ADMINISTRATIVE REPORT

Title: DAV 24-271912\C – 915 McMillan Avenue

Issue: For consideration of a Variance associated with a mixed use building.

**NEW MIXED-USE BUILDING
915 MCMILLAN AVENUE**

Figure 3: 45-degree view to Stafford St. from 909 McMillan Ave.

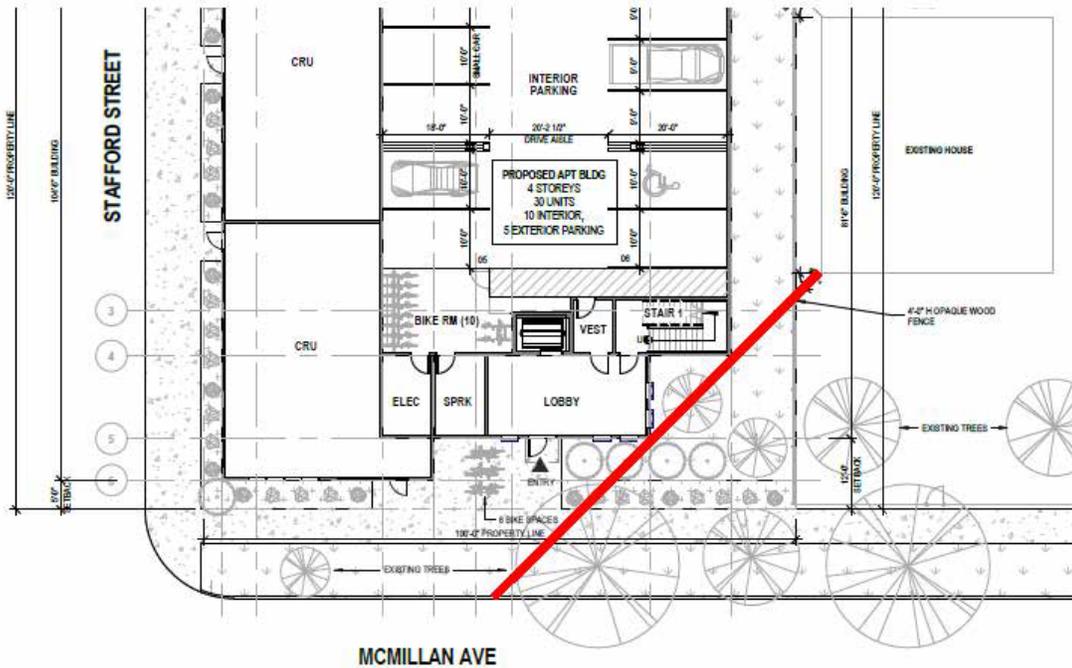
As noted above, the applicant is providing a staggered front setback ranging from 5 ft. on the western portion of the site to 26 ft. on the eastern portion (see Figure 3 below). Doing so reduces adverse impact on the east-abutting neighbouring property by providing a 45-degree angular horizontal views to Stafford for that property. This was a request that was made by the

Division in the 2021 application, which was made at that time and has been carried forward with the subject application.

For the above reasons, the Division supports this variance.
